# SOUNDSIDE

**COUNTY OF CURRITUCK  
SPECIAL USE PERMIT EXTENDED**

**FACILITY COMPLIANCE AUDIT REPORT**  
**Division of Waste Management**  
**Solid Waste Section**

SOUNDSIDE RECYCLING

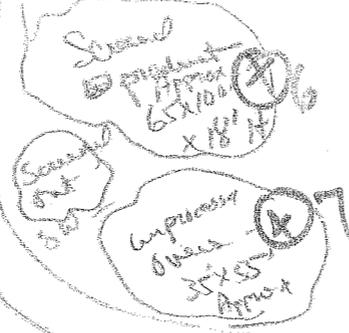
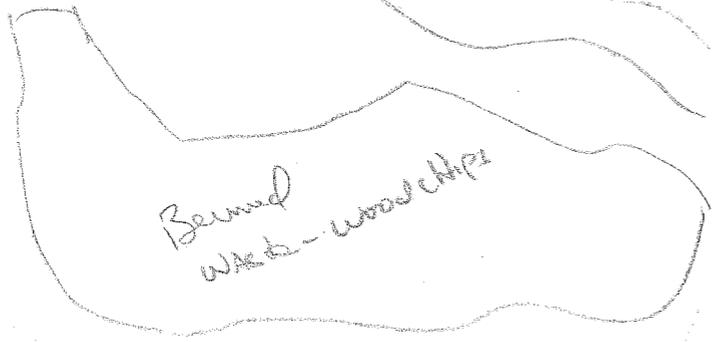
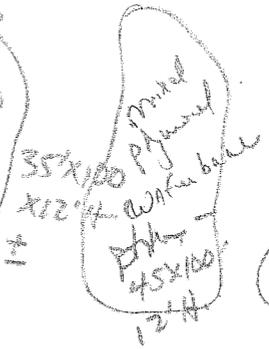
Area off permitted boundary

APP 625' x 95' - 100W -

Depth 4'-6" Wood chips - mixed waste ie plastics wood chips etc

755' x 60' x 20-25' H.

Behind waste mixed chips - wood waste.

SITE PLAN

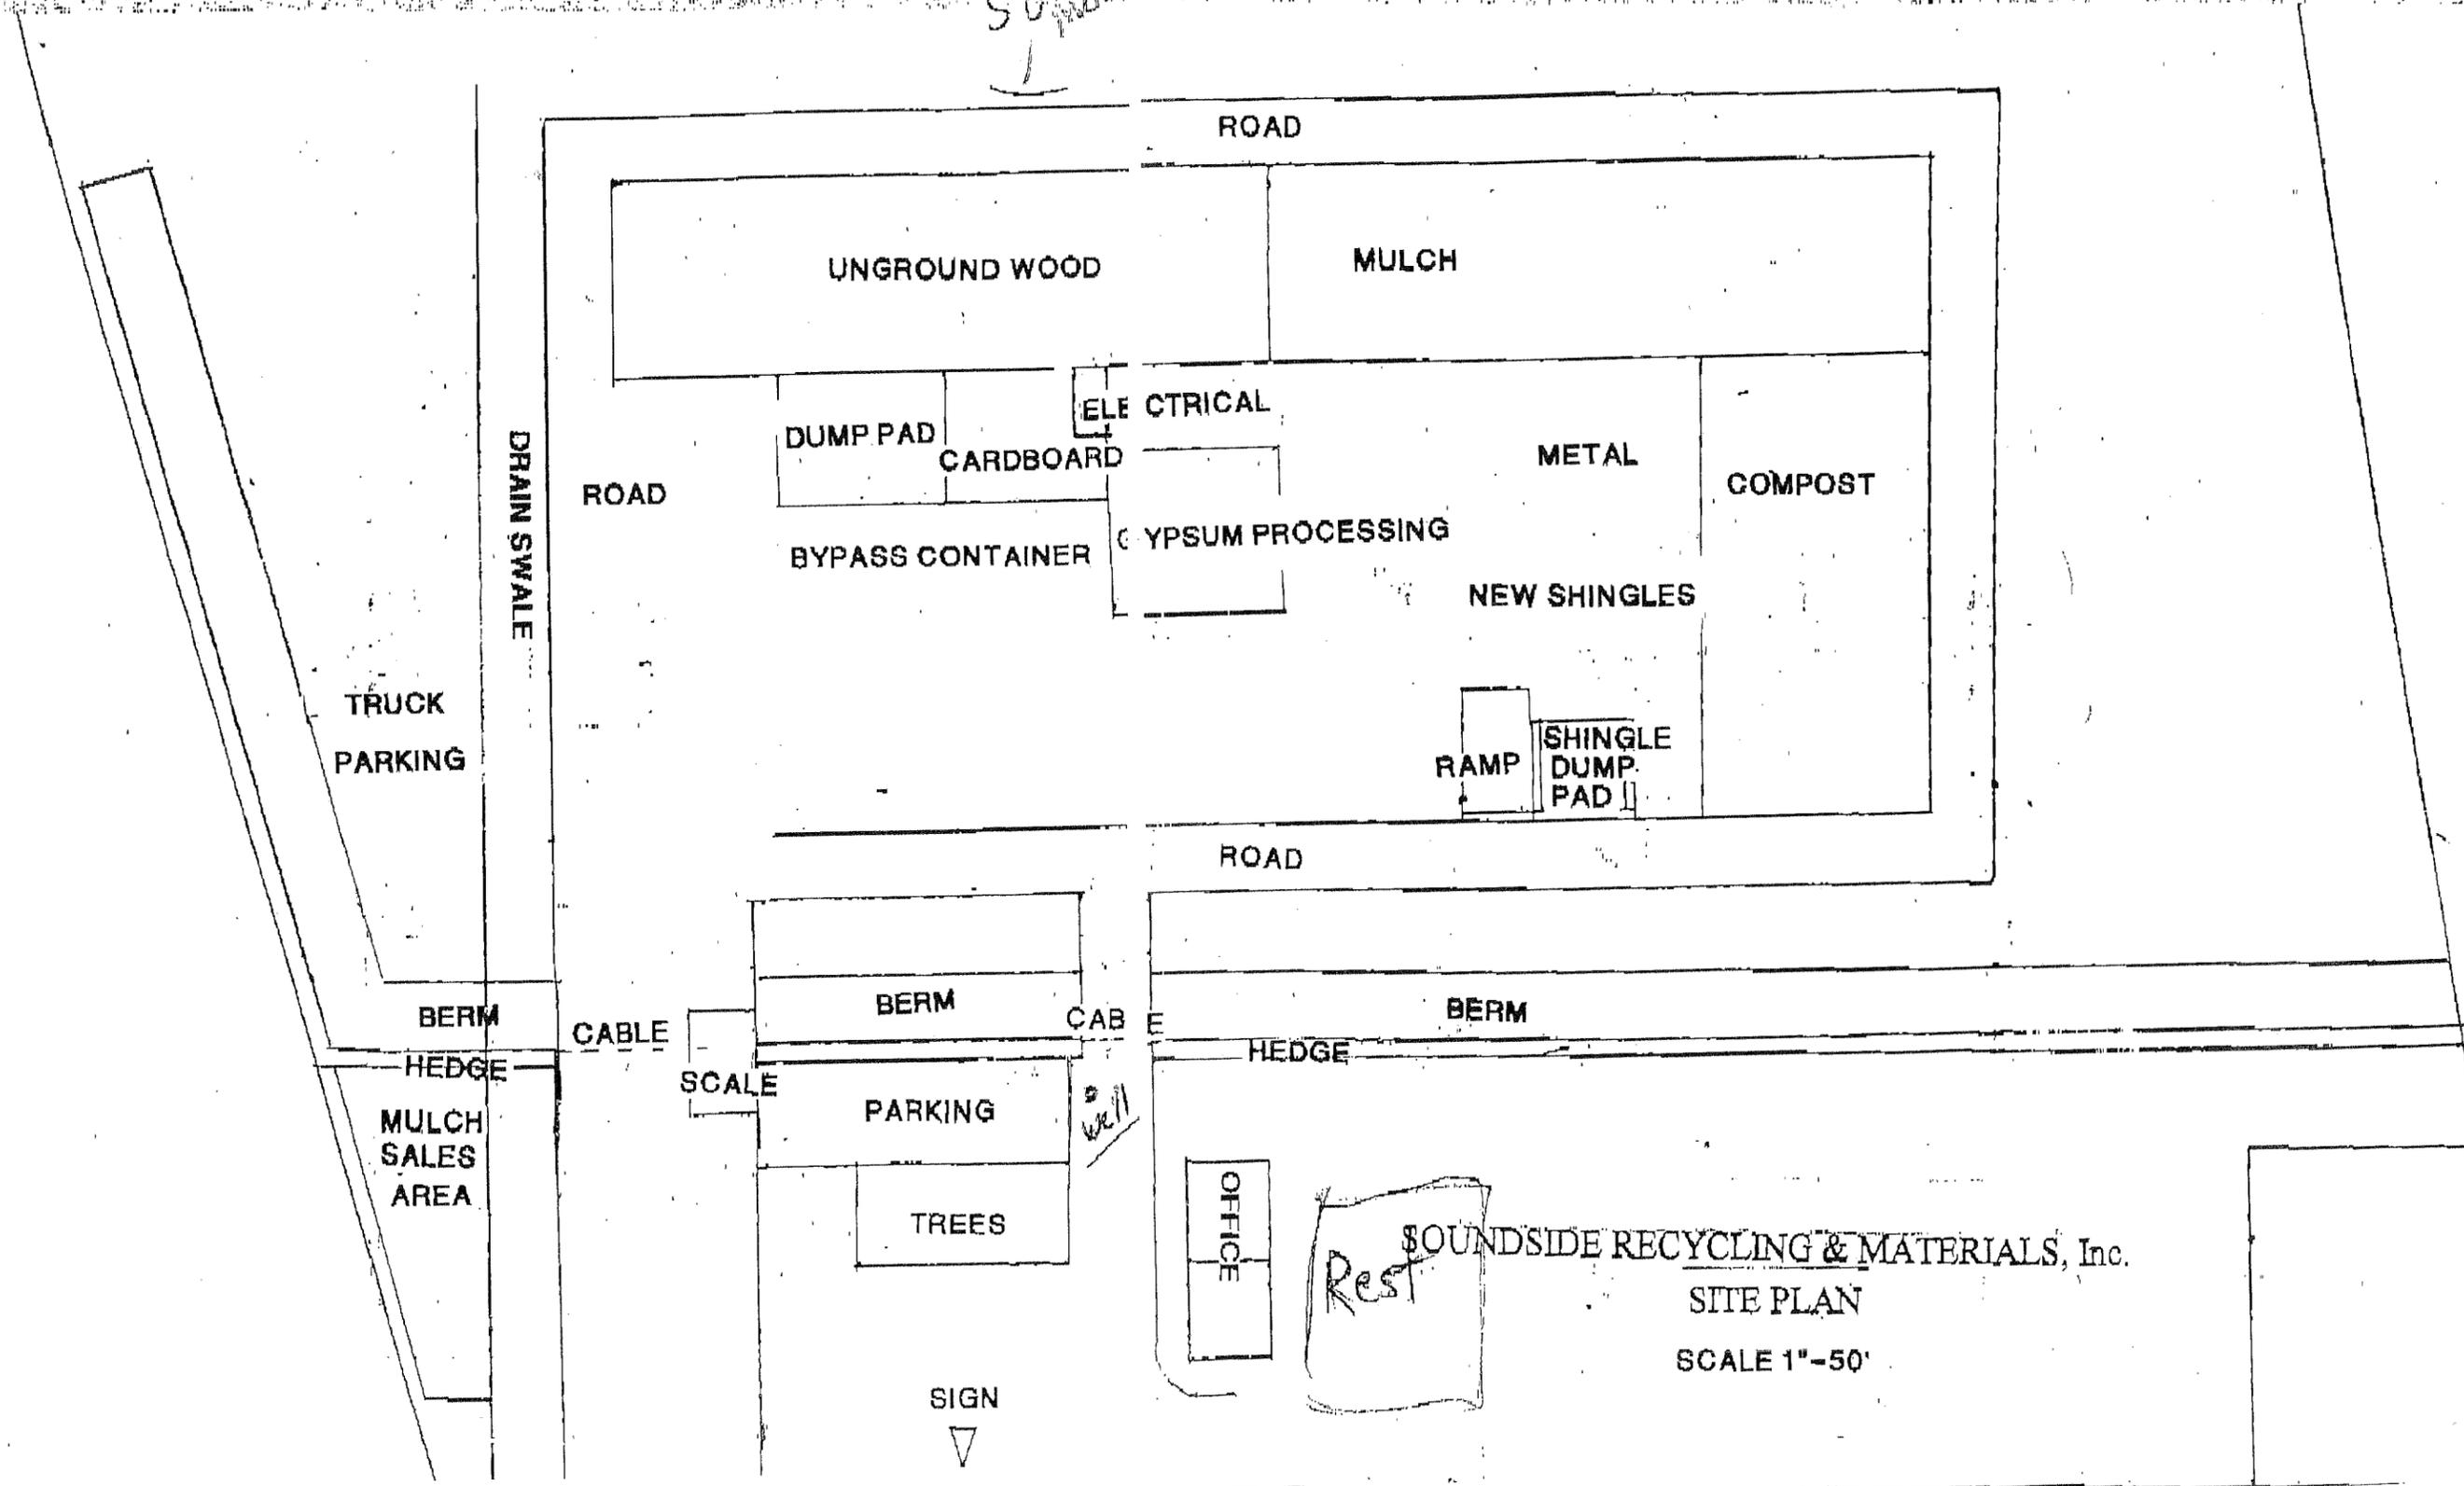
There is a large mulch pile located behind the property line of the facility. I would estimate that the pile contains from 4000 to 5000 cubic yards of material.

This large mulch pile is from 50 to 100 feet behind the property line of the facility
